BURLINGTON DEVELOPMENT REVIEW BOARD

Wednesday March 6th, 2019, 5:00 PM

TO: Development Review Board
FROM: Ryan Morrison
DATE: March 6, 2019
RE: 19-0566SD; 54 South Winooski Ave

Request: Combined preliminary & final plat review of a 3-lot subdivision; no proposed development.

PROPOSED SITE PLAN

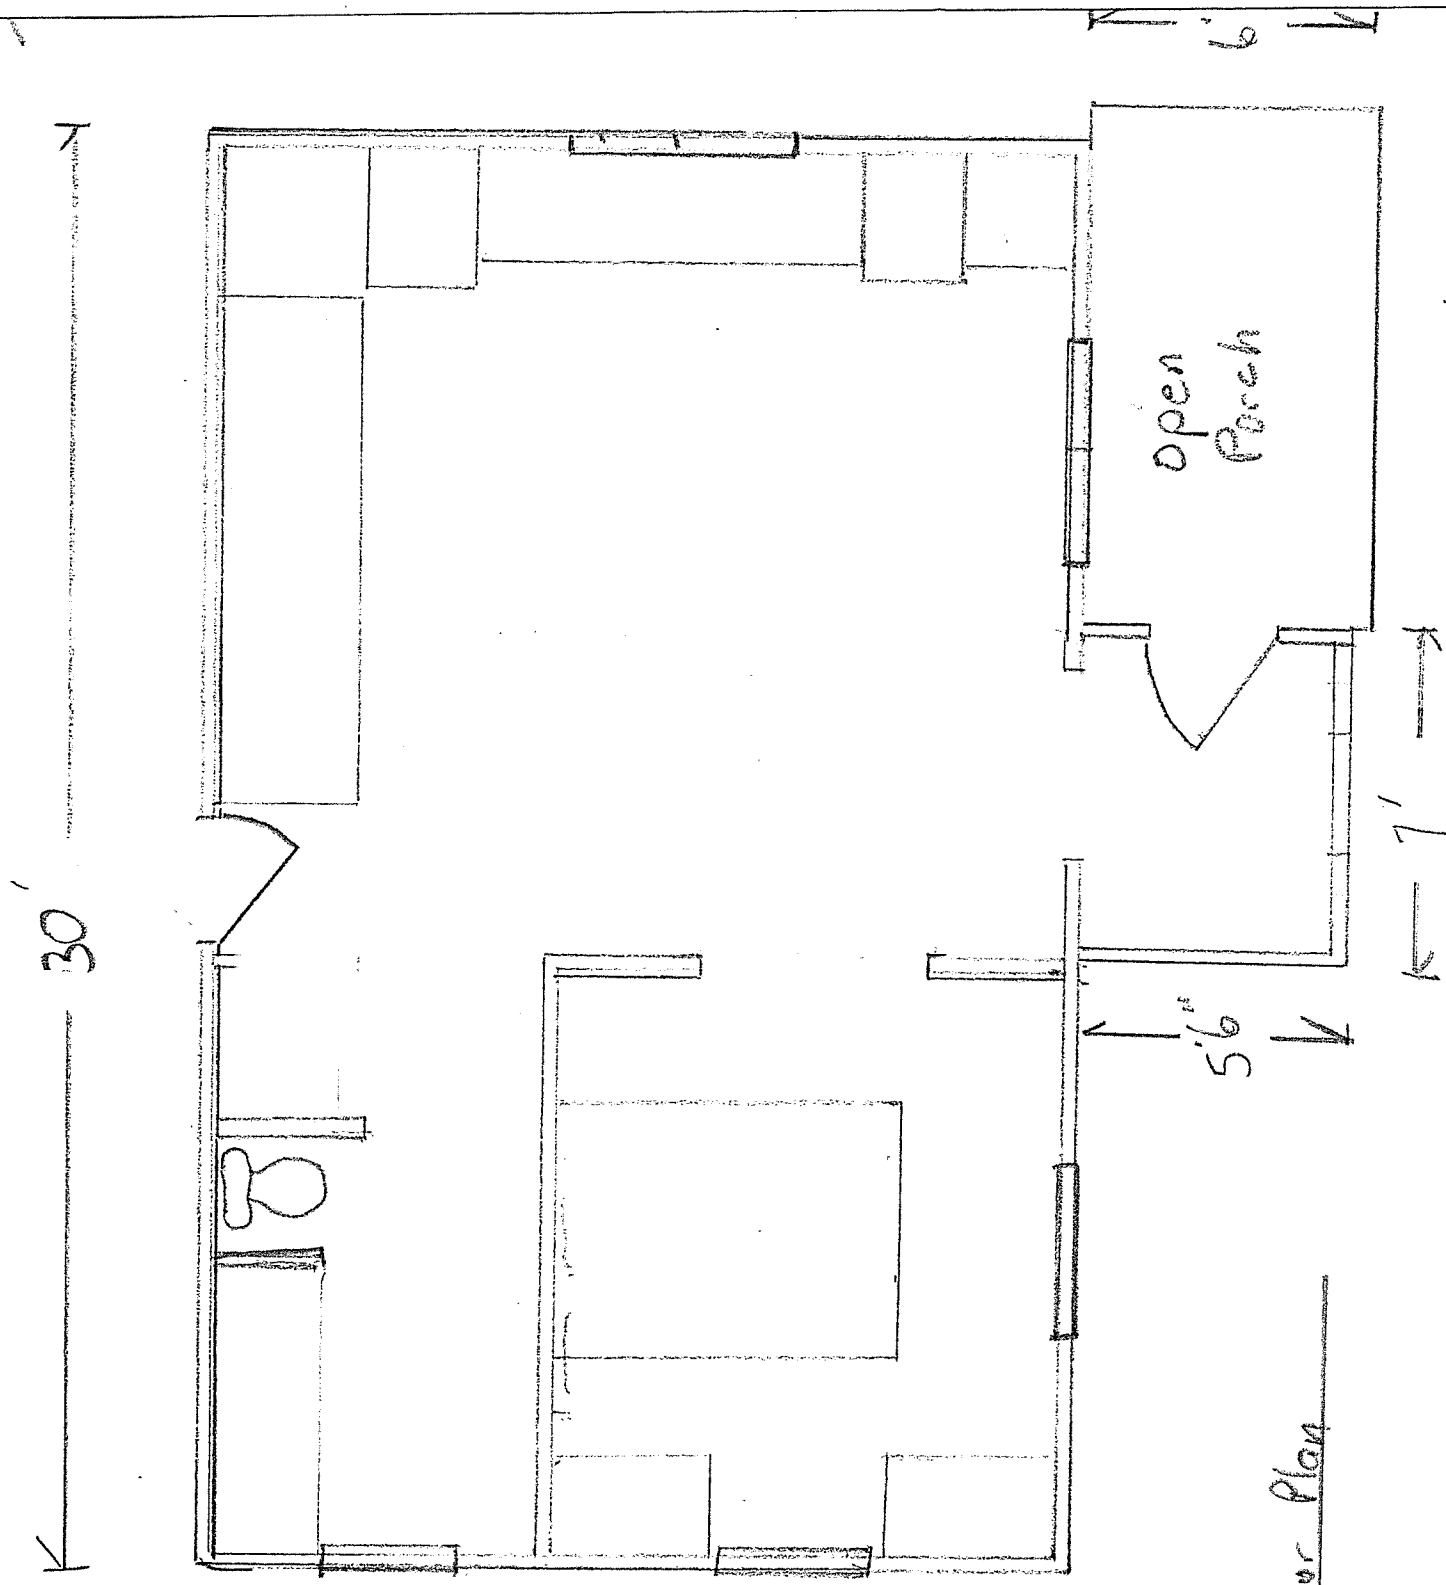
4. *One additional parking space which may be legally allocated to the necessary unit must be provided for the accessory unit;*
The site plan shows a total of 3 parking spaces, 2 that are required for the main residence, and 1 required for the accessory dwelling unit. **Affirmative finding.**
and

Single family uses require 2 parking spaces in the Neighborhood Parking District. Section 5.4.5 (a) (4), above, sets the parking requirement of 1 space for accessory dwelling units. The site plan shows parking for 3 vehicles. **Affirmative finding.**

South Elevation
1/4" = 1'

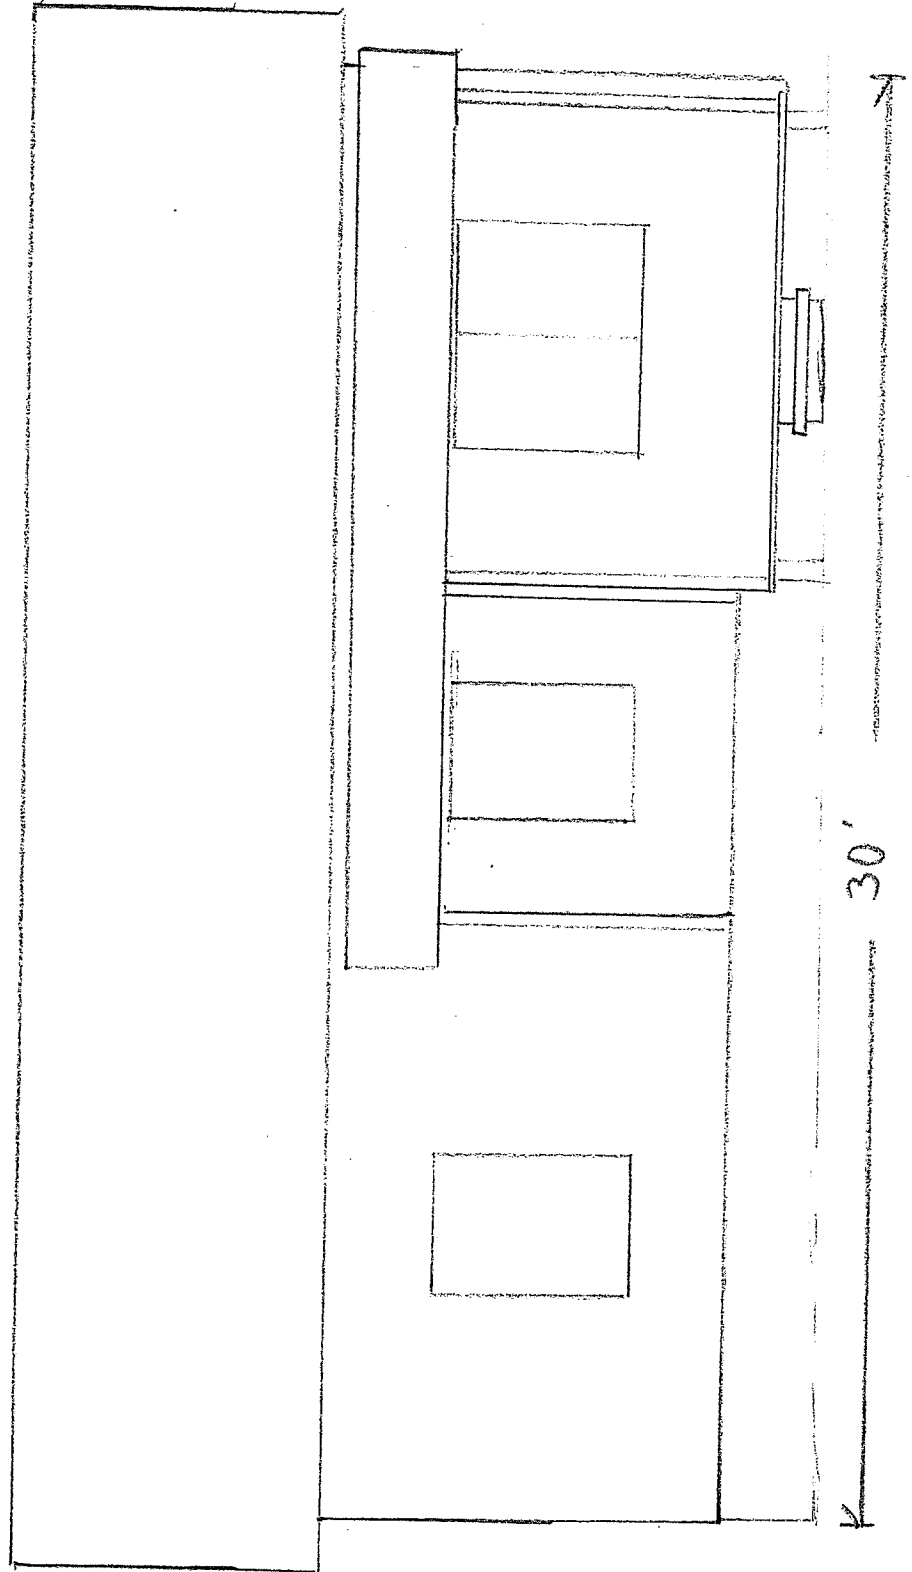
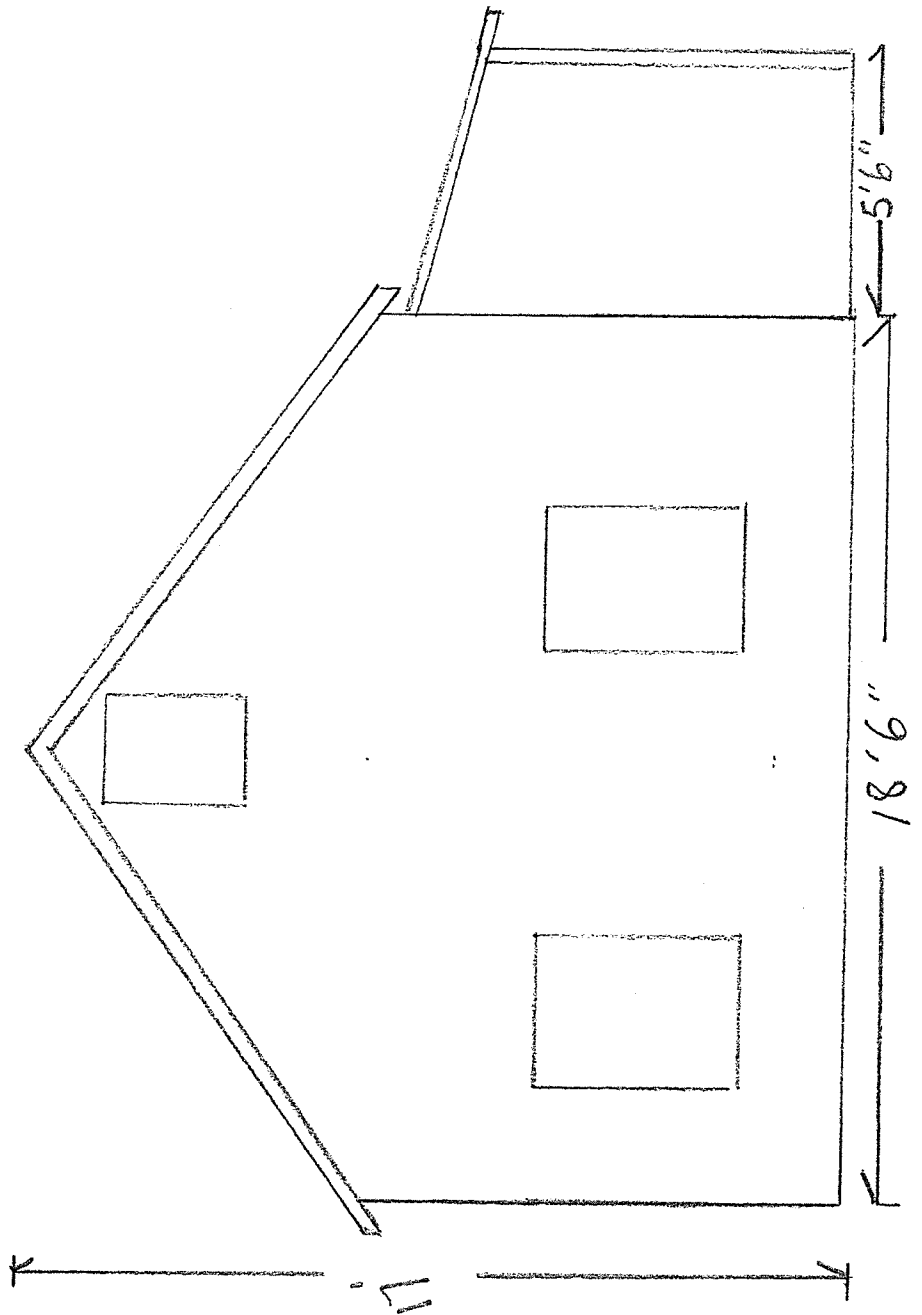
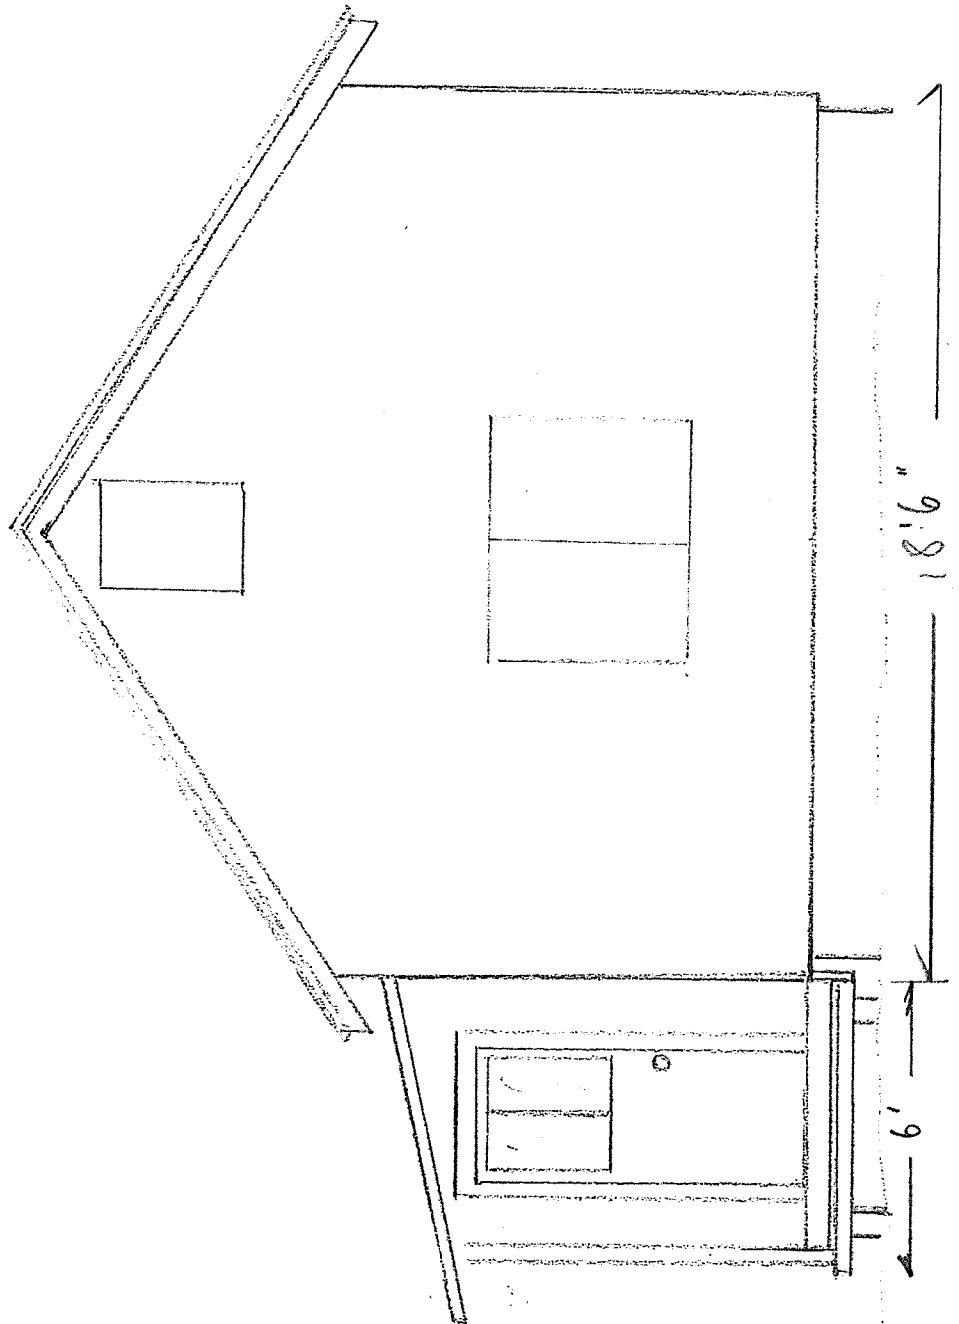
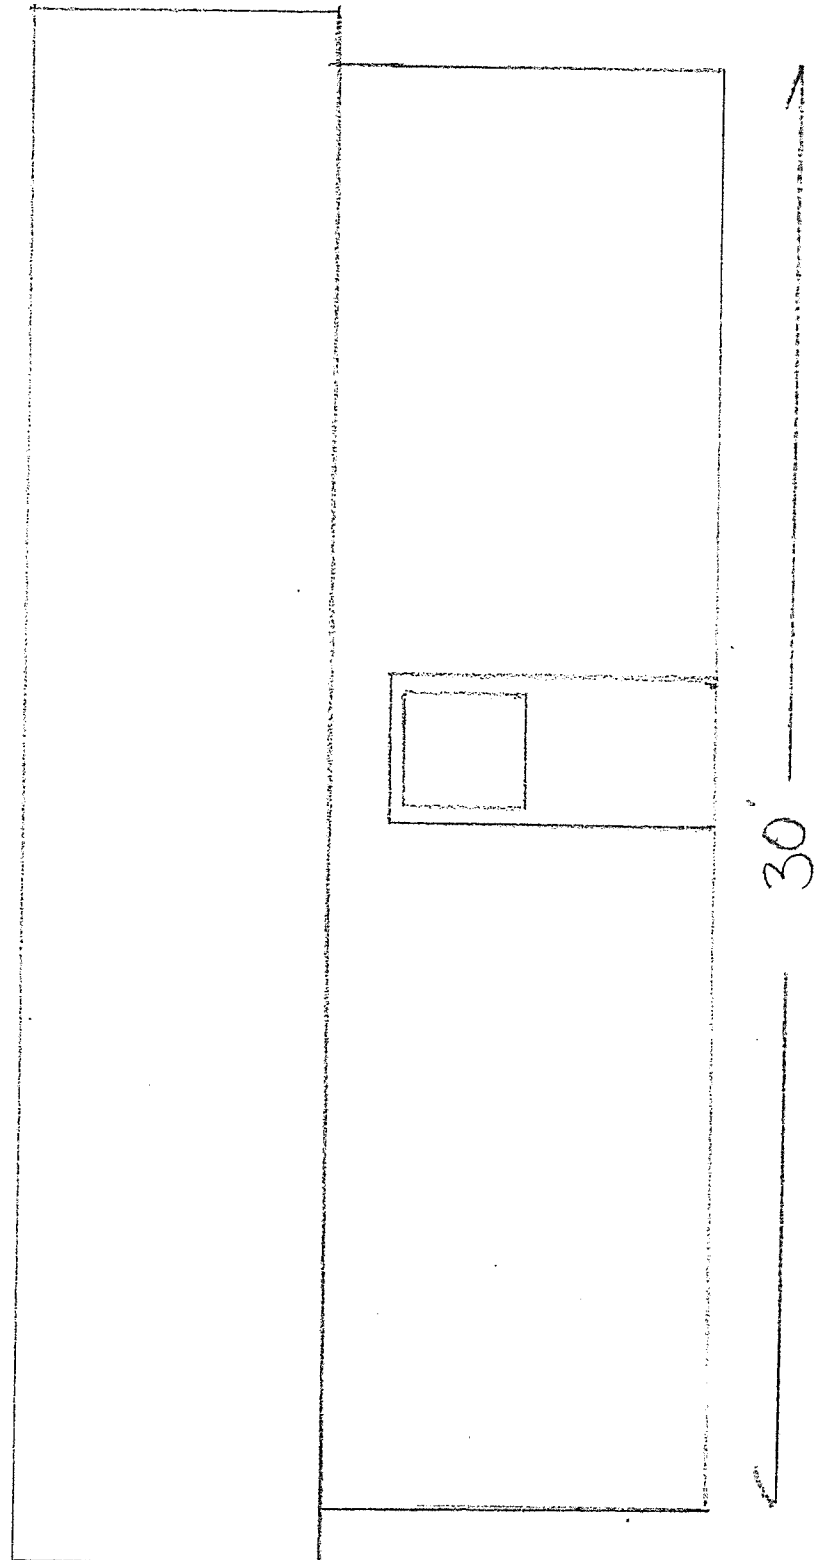
It is assumed that the new structure will have exterior lighting, however the plans do not show light fixtures, and cut sheets have not been submitted for review. The applicant will be required to submit the required lighting information for administrative review and approval prior to the release of the zoning permit. The lighting must comply with the lighting standards of Sec. 5.5.2.

2. **Prior to release of the zoning permit**, the applicant shall submit revised elevation drawings showing the location of any exterior light fixtures, and provide spec sheets for those light fixtures, to staff for review and approval.
